STATE OF NORTH CAROLINA
DEPARTMENT OF TRANSPORTATION

Subject: Revised Application for Individual Section 404 and 401 Permits and Neuse Riparian Buffer Authorization for the construction of the southern section of Crescent Road from US 70 to US 258 in Lenoir County, west of Kinston. State Project No. 8.2200101. Federal Aid Project Number STP-224(3). TIP No. R-2719A., WBS 34501.1.1.

The purpose of this letter is to provide a revision to the application for a Section 404 Individual Permit, Section 401 Water Quality Certification, and Neuse Riparian Buffer Authorization. In addition to the cover letter this application package includes the following: revised permit drawings, a set of revised half size roadway plans, and a revised mitigation plan.

PLAN VIEW
 SITES 7 CON'T.
 & 8

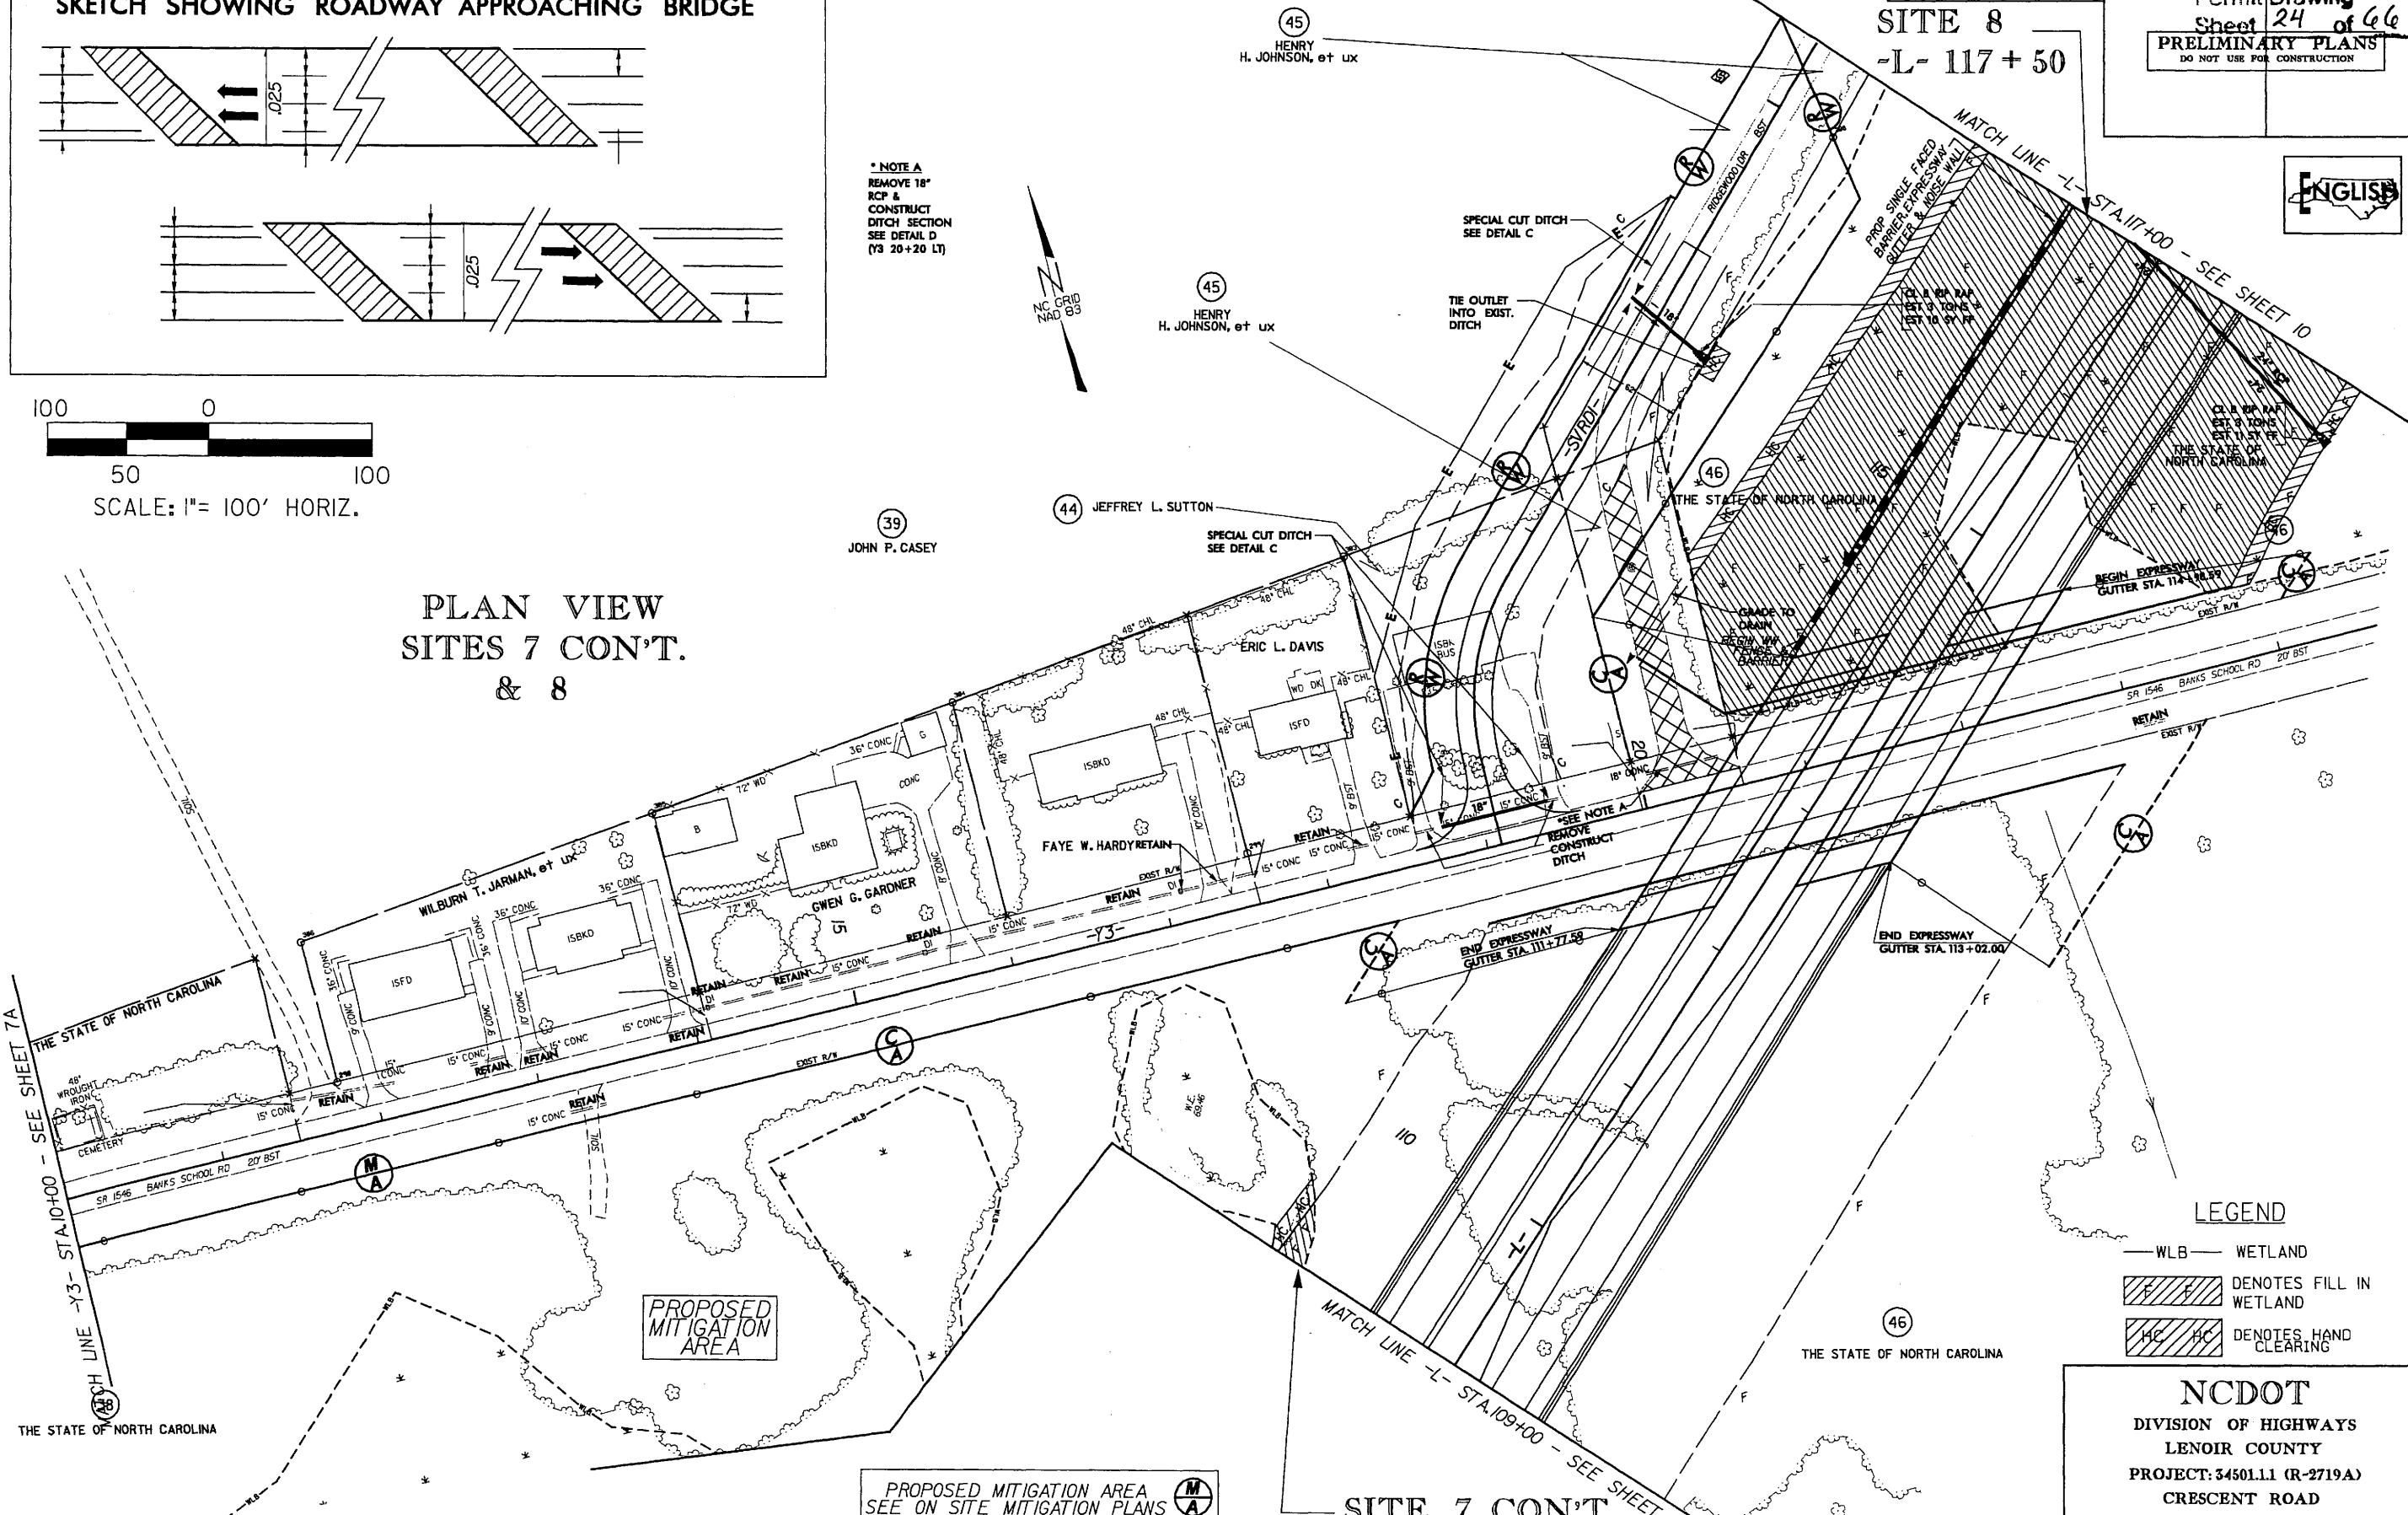
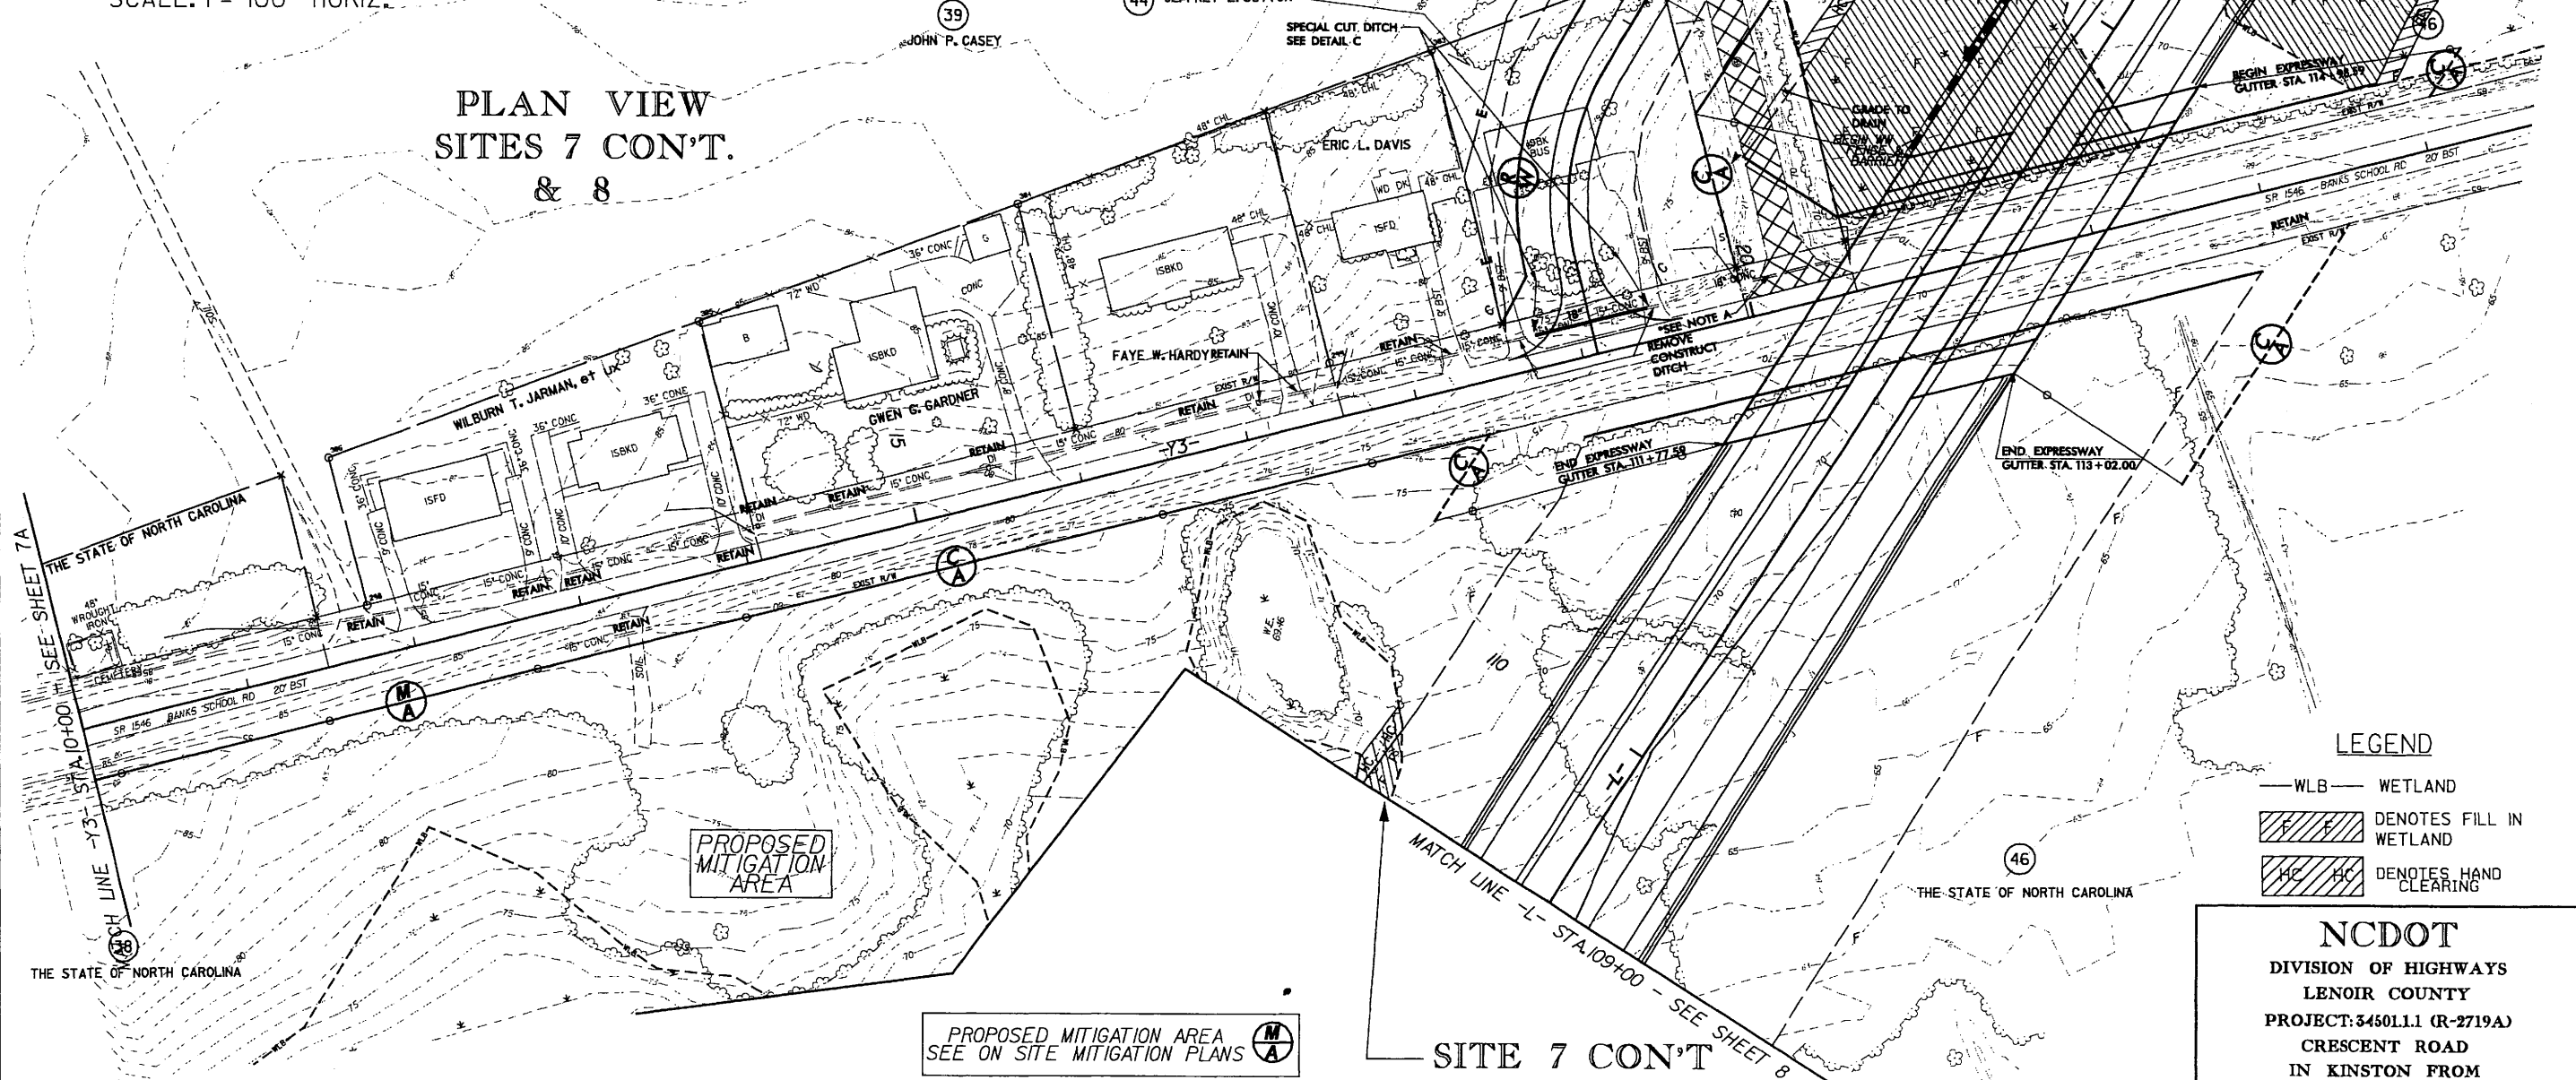
This revision describes the changes in the wetlands impacts due to the outcome of the reverification of the wetlands; also to describe the design change at the railroad crossing. NCDOT redelineated wetlands, due to the expiration of the jurisdictional determination. Several of the wetland lines were shifted as a result of this redelineation. Permit sites 8, 9, 10, 14, and 16 were changed and were verified by William Wescott with the USACE on March 6, 2008.
